**DRAFT FINDINGS OF FACT
Major Development Review
Combined Sketch and Final Site Plan
Planning Board Approval: May 12, 2015**

Project Name: Medical Office Building
Address: 84 Baribeau Drive
Case Number: 15-017
Tax Map: Map 22, Lot 31
Zoning District: Town Residential 4 (TR4)
Applicant: Smiling Sailboat Holdings, LLC
80 Pleasant Street
Brunswick, ME 04011

RE: **Stormwater Management Drainage Plan Review -Proposed Medical Office**
 84 Baribeau Drive-Brunswick, ME
 Lot 22-81
 C/o Smiling Sailboat Holdings, LLC

TYPICAL DRY POND DETAIL

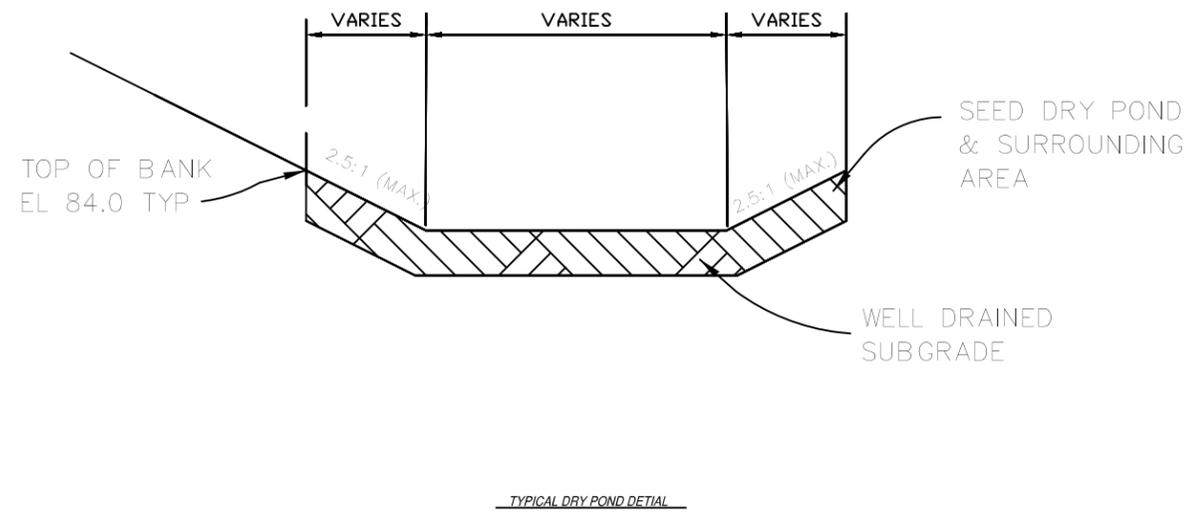
3. Upon inspection of the southern pond along the building and edge of property we noticed that there was a note for an overflow weir but was unable to locate any detail. Please provide a cross section of the weir or spillway.
